| Office Action Summary | Application No. 10/558,386 | Applicant(s) KADDANI ET AL. | |

DETAILED ACTION

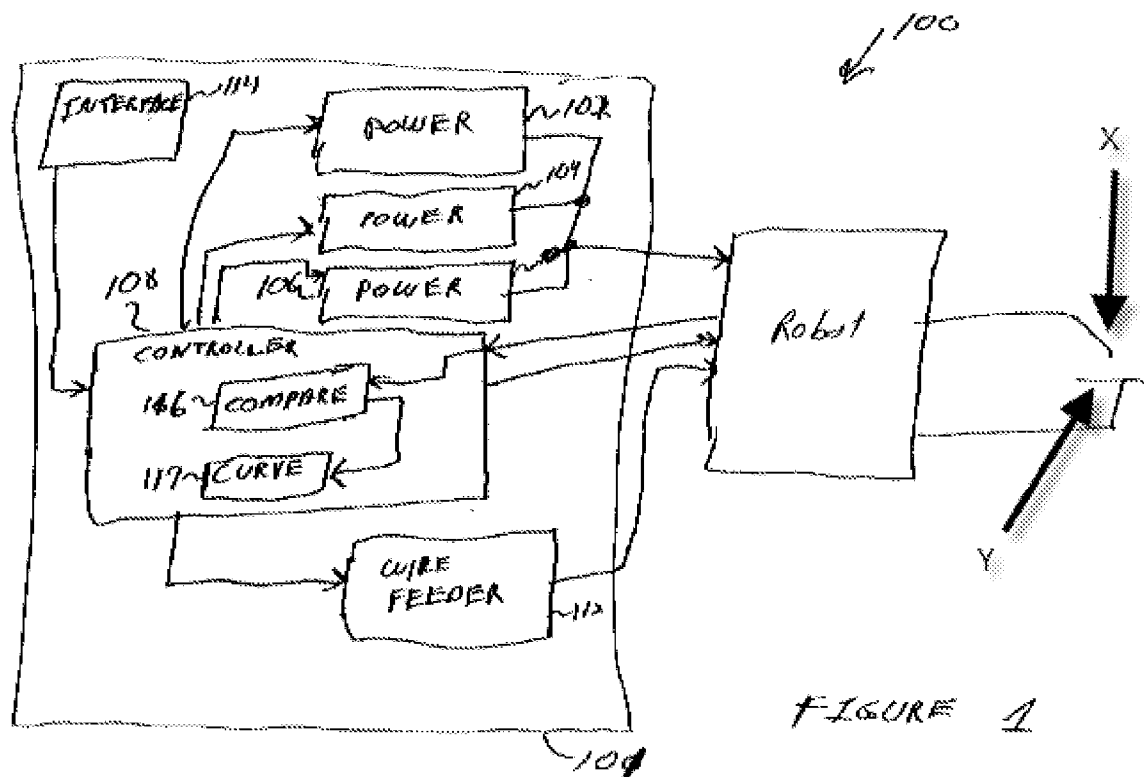
With respect to claim 15, Rappl et al. disclose the metal transport between the electrode X (Fig. 1 below) and the workpiece Y (Fig. 1 below); and parameter values for properties related to the power source 102/104/106 (fig. 1), a wire 112 (fig. 1), and a weld profile (see figure 1 below, para. 0002, and 0032).
